Re: Duke Energy Florida Citrus County Combined Cycle Project Completeness Responses,
DOAH Case No. 14-3632EPP, OGC Case No. 14-0431

Pursuant to Section 403.5066(2), Florida Statutes, Duke Energy Florida (DEF) hereby submits information responsive to the Florida Department of Environmental Protection's First Determination of Incompleteness issued September 10, 2014.

Duke Energy Florida, Inc. Citrus Combined Cycle Project Completeness Responses

Figure 2-1: Schematic of Dry Detention System

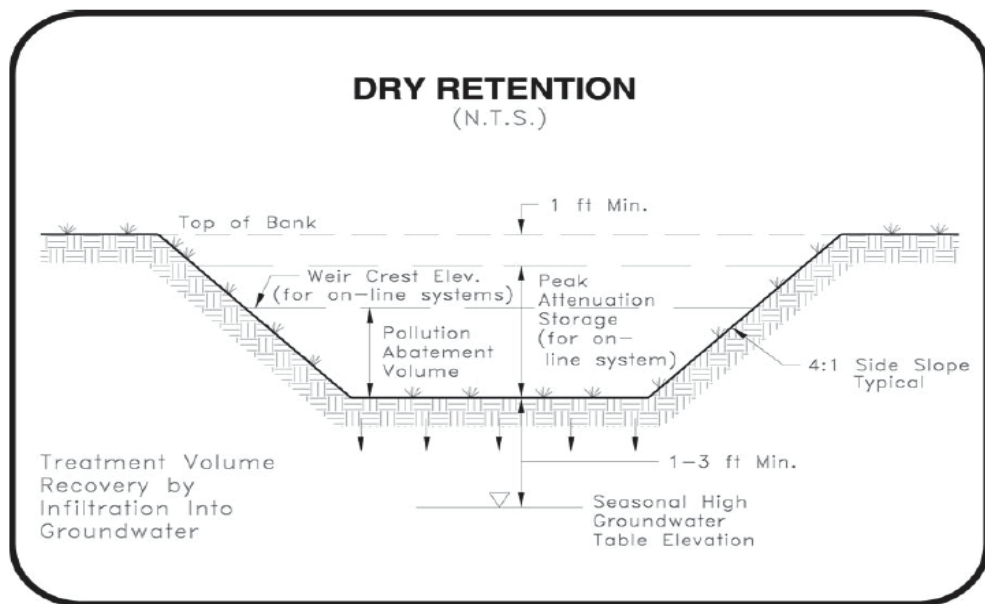
3. *The design of the dry detention ponds (Stormwater Detention Pond #1 and #2) should be revised so as to not include a bleed down orifice. Dry detention ponds obtain treatment through infiltration of the treatment volume via underdrain or infiltration. [Pursuant to Applicant's Handbook, Volume II, Section 4.1.b or c]*

The dry detention ponds have been revised to include infiltration, and the typical infiltration pond section has been added in the revised Conceptual Stormwater Design Basis report drawings, which are provided in Attachment B. The bottom of the infiltration area will be reduced by increasing the water depth. The control elevation has been kept the same, so the overall pond area will not change.

The dry pond discharge and calculations have been revised with the soil infiltration rate of 0.375 inch per hour (in/hr) for 36 hours of treatment volume. Attachment B provides the revised Conceptual Stormwater Pond Design Basis report.

CITRUS COUNTY COMBINED CYCLE STORMWATER DETENTION POND #1 PLAN, SECTIONS & DETAILS	
project	contract
71404	
drawing	rev.
CS316C	-A
sheet	sheets
file 71404CS316C.dgn

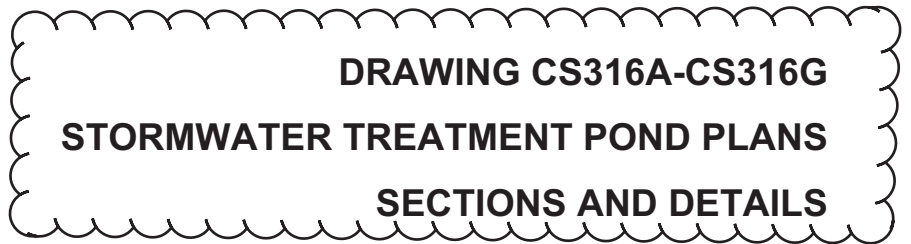
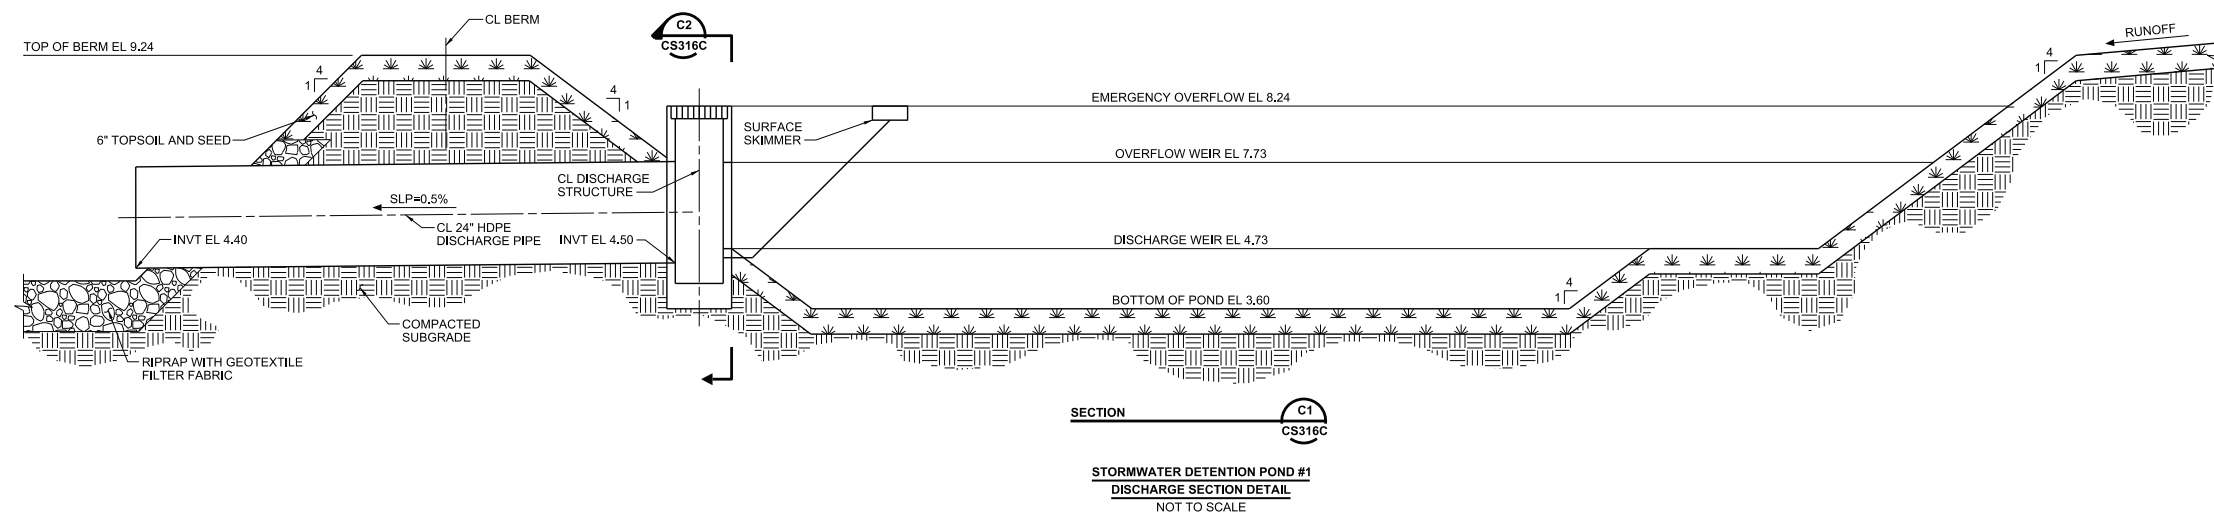
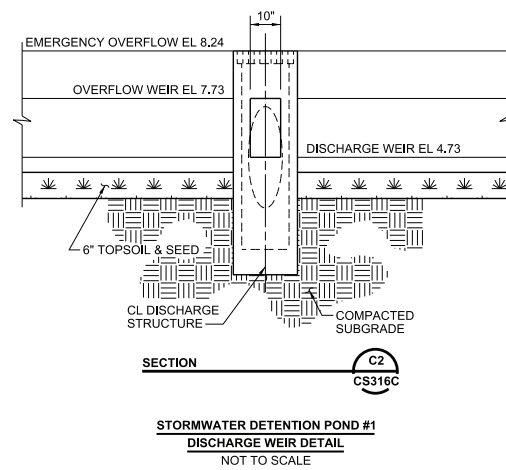
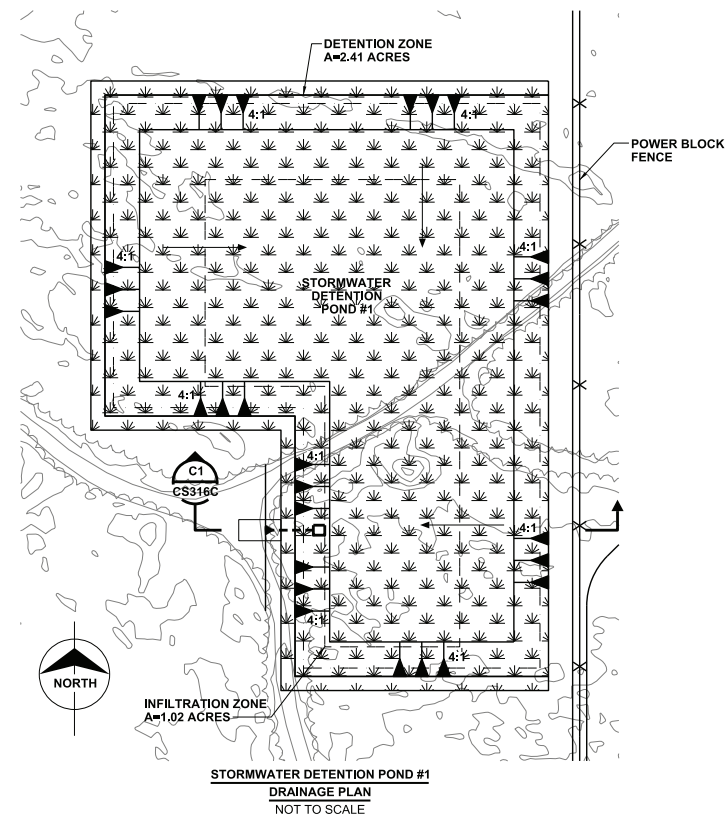
1. *Please revise the design of the wet detention ponds (Construction Stormwater Treatment Pond #1 and #2, and Stormwater Detention Pond #3, #4, and #5) to include a littoral zone. [Pursuant to Applicant's Handbook, Volume II, Section 4.l.a.2] FYI, wet detention ponds can be permitted without the use of littoral zones provided that the permanent pool volume is sized 50% larger than the calculation provides. If the applicant desires to not provide a littoral zone, please provide design revisions showing the 50% increased pool volume.*

The discharge structure has been modified to have a baffle at the top, and the weirs will not allow flow from the bottom of the ponds, since the control elevation is above the treatment volume. Drawings including the skimmer and baffle systems are provided in the revised attached Conceptual Stormwater Design Basis report, which is provided in Attachment B.

Table 4.5.1-1. Projected Effluent Temperatures (Revision 1 - 10/10/14)

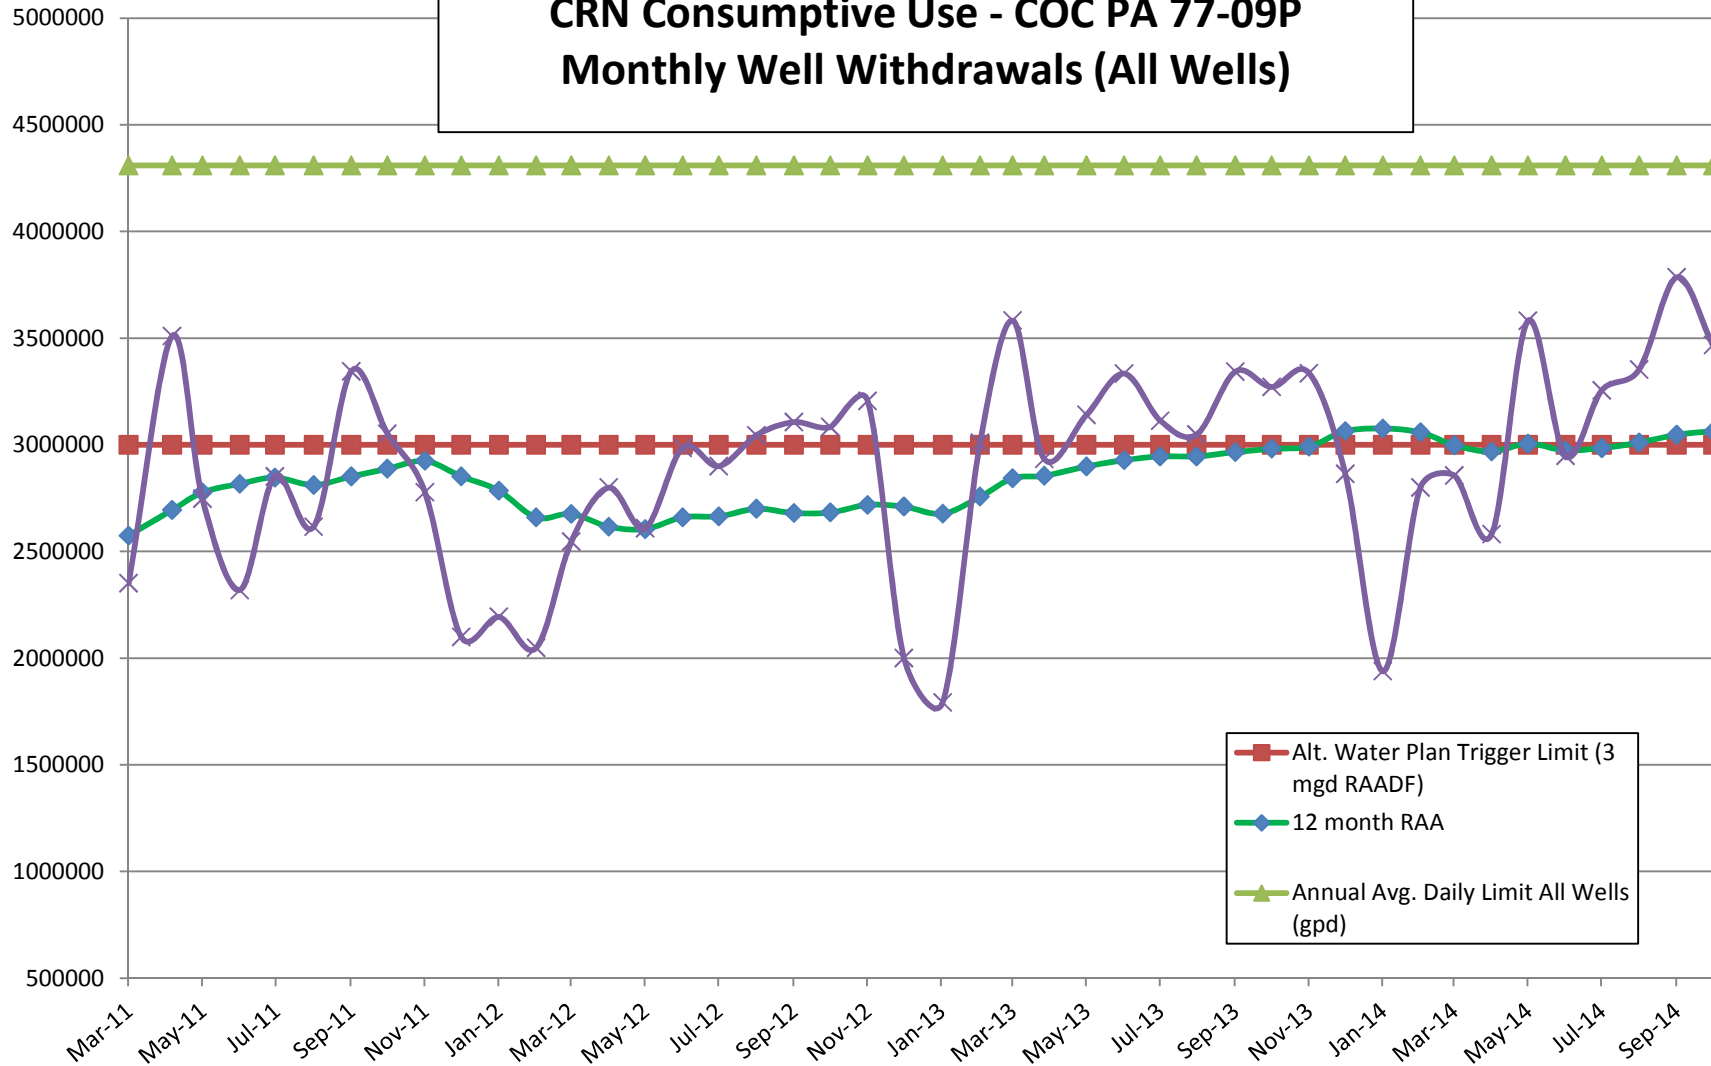
1. *Anticipated effects of discharge water: We note that the temperatures provided in Table 4.5.1-1 are based on average seasonal water temperatures observed in the intake water for the months of March through November. To fully understand the potential effects of the thermal discharge from the proposed CCC facility on aquatic resources, we request that the applicant provide a similar projection of effluent temperatures for intake water from the months of December through February. The winter months are the ones during which the water temperatures in this area are most critical to the West Indian manatee (Trichechus manatus, Federally Endangered).*

The revised Table 4.5.1-1, Projected Effluent Temperatures, provided in Attachment F, has been updated to include the scenario of average seasonal water temperatures for the months of December through February.
